STAFF REPORT 12-08-2021 REGULAR MEETING

APPLICATION NUMBER: 21-7634

ADDRESS: 1501-1541 CHURCH

SCOPE: REVISION OF PREVIOUSLY APPROVED APPLICATION; CHANGES TO WINDOWS AND WINDOW OPENINGS, MATERIALS

Areas of proposed revisions to originally approved scope indicated with revision clouds..

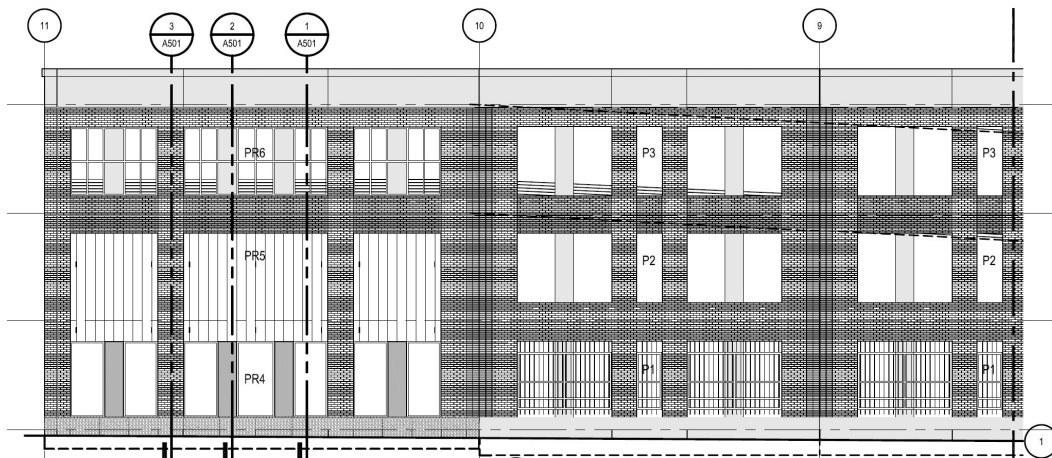
- Remove all granite base from building, currently approved for the base of the NW and SE towers, and at the NE storefront (east elevation), in favor of pre-cast concrete base to match the remainder of the building.

- Replace metal panels currently approved at top of NW elevator override tower; will be replaced with brick expression to match the remainder of the building (i.e., brick embed in pre-cast).

- Removal of crossed interior muntins from mullioned windows at towers, resulting in larger panes. Previous approved design showed muntins, which staff interpreted as true divided lights but the applicant wished to interpret as interior- or exterior-applied (adhered).

- Replacement of previously approved spandrel glass panels at NE storefronts, not technically feasible due to adjacent concrete columns, with pre-finished metal closure panels colored to match window frames

- Substitution of fence-like closure of openings around base of building with 4" mesh grid. Addition of mesh grid in other openings at the south, east, and north elevations.

New opening types now proposed, per elevation on page 2. Representative photo of wire mesh, per applicant..

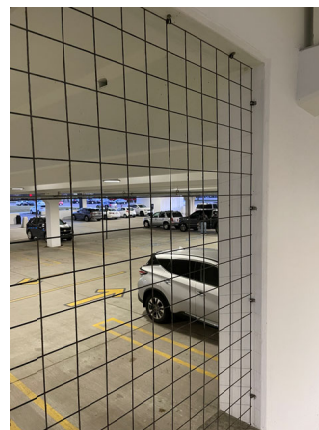
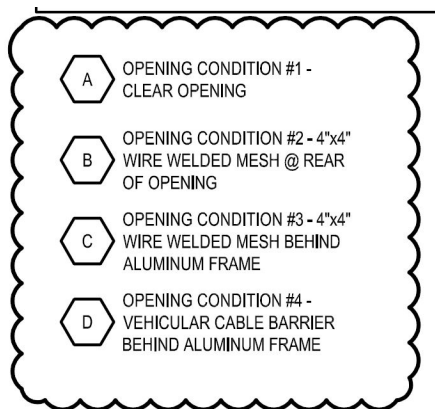
- As for the openings, the applicant now seeks to establish four types of openings per the modified note and marks reproduced below (i.e., A, B, C, and D as indicted on the elevations). Types C and D preserve the “unglazed window” expression (i.e., “aluminum frame”) which was briefly at issue in the original approval for the east/storefront areas, with the new mesh element installed behind. The expression of the building will be different than approved; however, the removal of the fence-like enclosure at the first story is aesthetically desirable, and staff finds that the overall effect to be more cohesive and not inappropriate for a new construction building of this type.
